ADDENDUM NO. 1

ISSUE DATE: **September 14, 2026**

RE: **BIRGE L&S 4TH FLOOR BIOLOGY RISE LAB RENOVATION
UNIVERSITY OF WISCONSIN-MADISON
MADISON, WISCONSIN**

UW-Institution Project No. 0054-2507

Project Number	0054-2507/A-25-004
Set Type	BD
Date Issued	08/27/2026
Sheet Number	A101

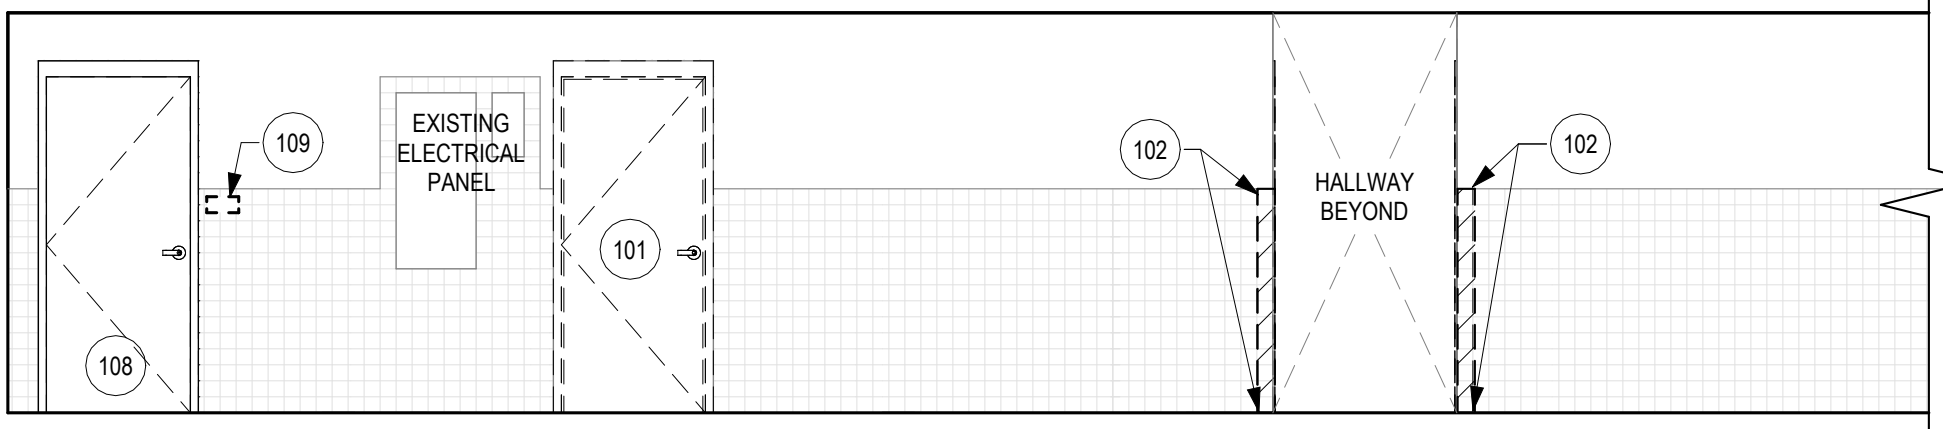
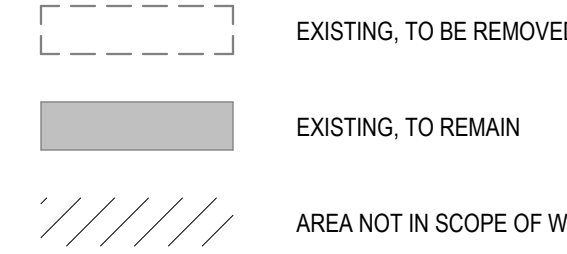
1. Sheet A101 – DEMOLITION PLAN – LEVEL 04
 - a. ADD General Demolition Notes To Contractor, Note 10
2. Sheet E400 – PROPOSED ELECTRICAL CONDUIT ROUTING
 - a. ADD MDP-1 Images for Reference
3. Sheet H100 – ASBESTOS ABATEMENT PLAN – LEVEL 04 – FOR INFORMATION ONLY
 - a. REVISE areas to be abated. (For Information Only).

- BEYOND THE DEMOLITION AND REPAIR WORK SPECIFICALLY IDENTIFIED IN KEYNOTE 117, THE SOURCE OF WATER INFILTRATION AND ANY INVESTIGATION, REMEDIATION, CORRECTION, OR REPAIR ASSOCIATED WITH THE WATER INFILTRATION CONDITION ARE NOT PART OF THIS CONTRACT. THE WATER INFILTRATION ISSUE WILL BE ADDRESSED UNDER A SEPARATE FUTURE PROJECT. THE CONTRACTOR'S RESPONSIBILITY UNDER THIS PROJECT IS LIMITED TO THE WORK SPECIFICALLY INDICATED IN THE CONTRACT DOCUMENTS AND SHALL NOT INCLUDE IDENTIFICATION, CORRECTION, OR WARRANTY OF THE UNDERLYING WATER INFILTRATION CONDITION.

1 ASBESTOS ABATEMENT PLAN - LEVEL 04

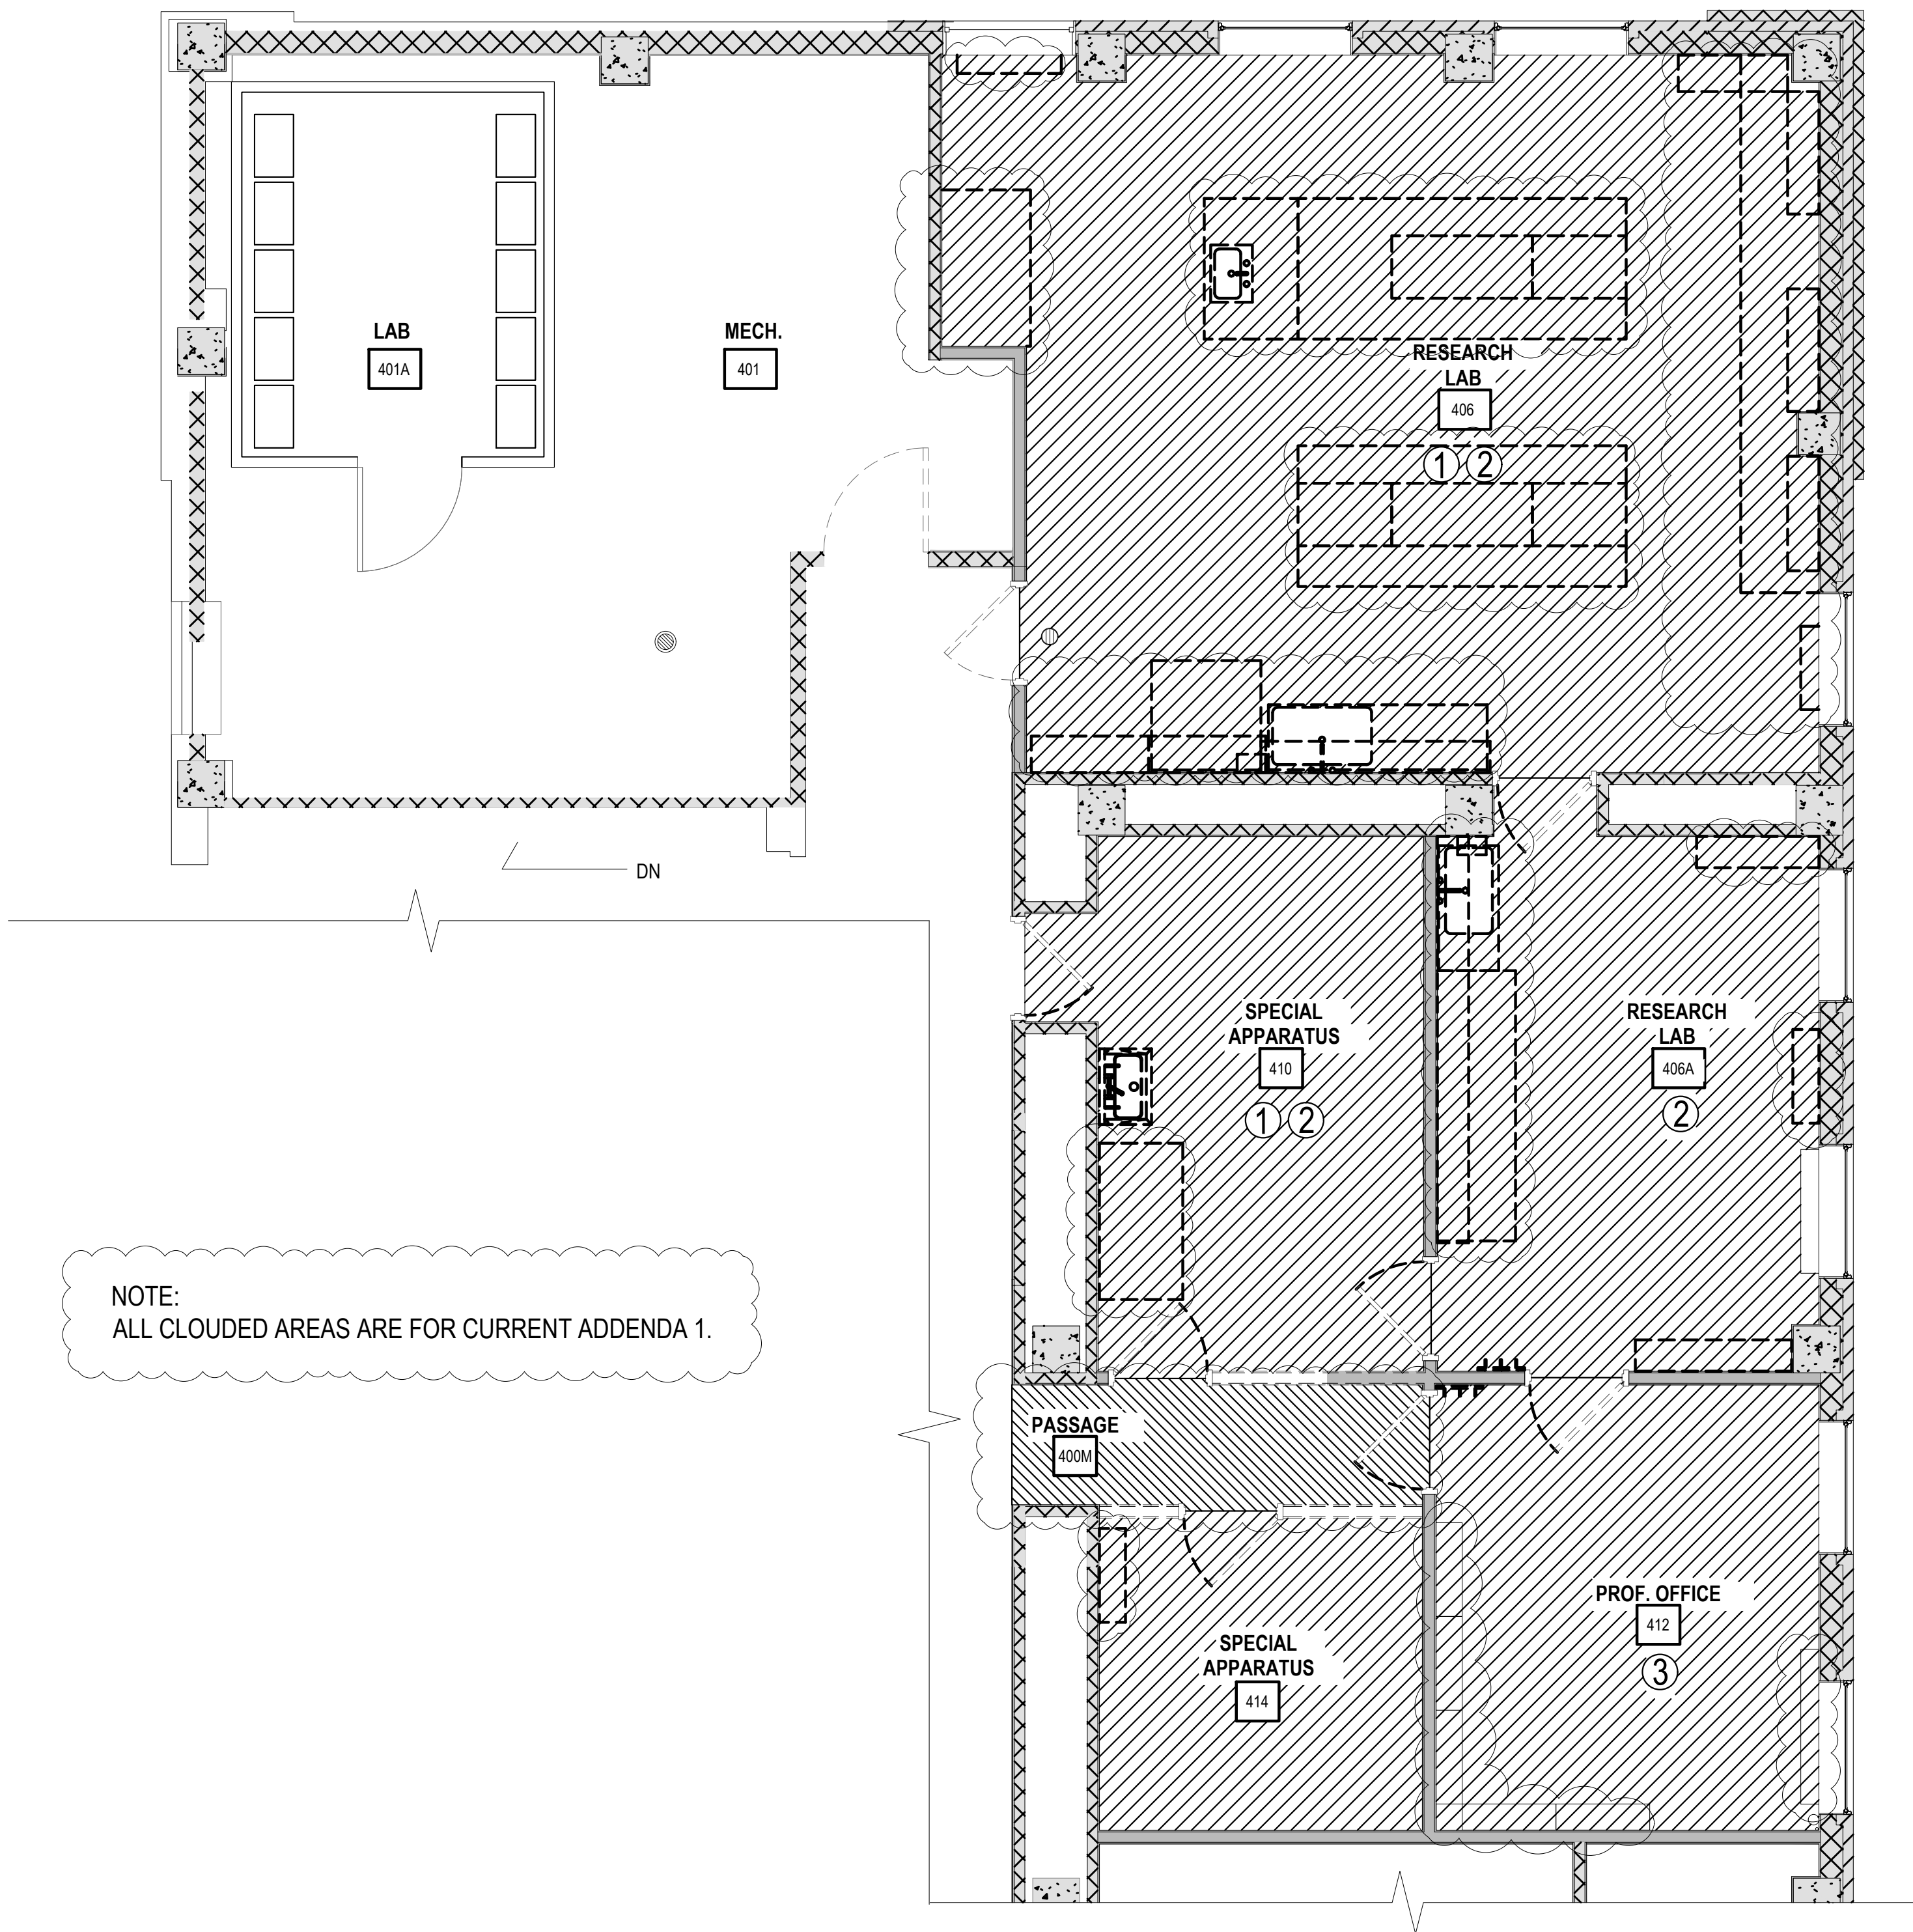
NOTE:
ALL CLOUDED AREAS ARE FOR CURRENT ADDENDA 1.
